CITY OF ROCKVILLE  
ROCKVILLE, MARYLAND

**Addendum #2**  
**Invitation for Bid (IFB) No. 01-25**  
**KING FARM FARMSTEAD ELECTRICAL INFRASTRUCTURE SERVICE PROJECT**

**Issued On: October 2, 2024**  
**Issued By: Christos Bazekis, Buyer**

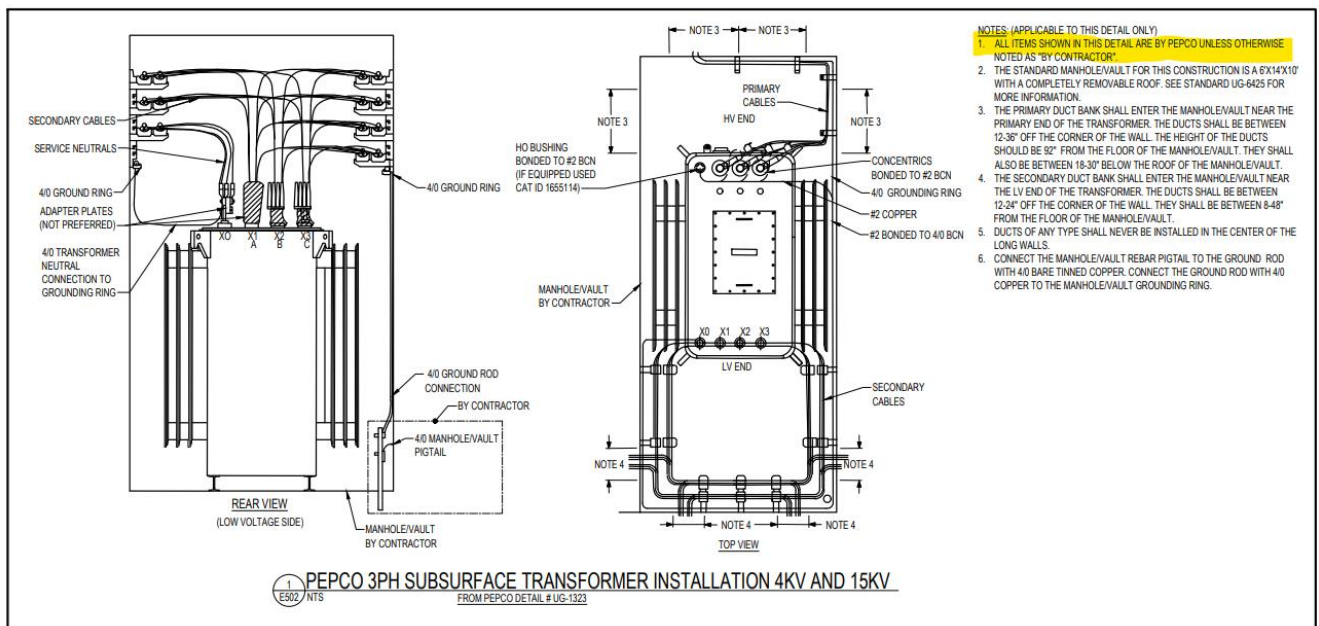
7. Will PEPCO be responsible for setting the manhole vault and splice box or will this be installed by the contractor?  
**Answer: The Contractor is responsible for providing the manhole vault and the splice box per Drawings ES102, E502, and E503.**
8. Want to confirm it's the contractor's responsibility to purchase and supply the components from PEPCO's material list for the manhole vault and splice box.  
**Answer: The Contractor is responsible for purchasing and supplying components from PEPCO's material list for the manhole vault and splice box. Items provided by PEPCO are stated as such on the Contract Drawings. Refer to detail 1/E502, note#1, and sheet ES102, conduit references "a" and "b" as examples.**

CONDUIT REFERENCE: (APPLICABLE TO THIS SHEET ONLY)

- (A) (2) 4"C - EMPTY CONDUITS WITH PULLSTRINGS, CONCRETE ENCASED (PEPCO UG MV PRIMARY - CONDUCTORS BY PEPCO)
- (B) (4) 4"C - EMPTY CONDUITS WITH PULLSTRINGS, CONCRETE ENCASED (PEPCO UG LV SECONDARY - CONDUCTORS BY PEPCO)
